Service Bulletin

Bulletin No.: P11037

Subject: Oil Pressure Switch Replacement Information

Models: 2013 Buick Encore
2011-2013 Chevrolet Cruze, Volt
2012-2013 Chevrolet Sonic
Equipped with Engine RPOs LUW, LWE, LUJ, LUU, LUV

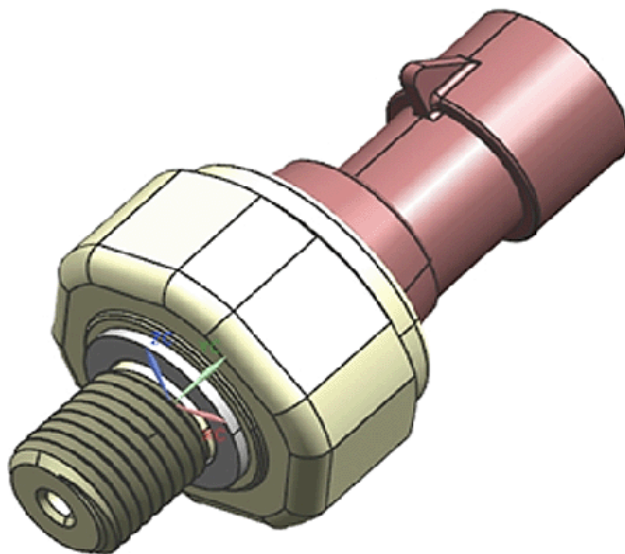
If replacement or removal of the oil pressure switch is necessary, it is important to torque the switch to the right specification. There is the possibility to have one of two switches available for replacement. Each switch has a different torque specification depending on which engine they are used on. Please see pictures below for reference.

LUW and LWE Oil Pressure Switch – 40 N•m (30 lb ft)

LUW, LWE, LUJ, LUV & LUU Oil Pressure Switch – 20 N•m (15 lb ft)
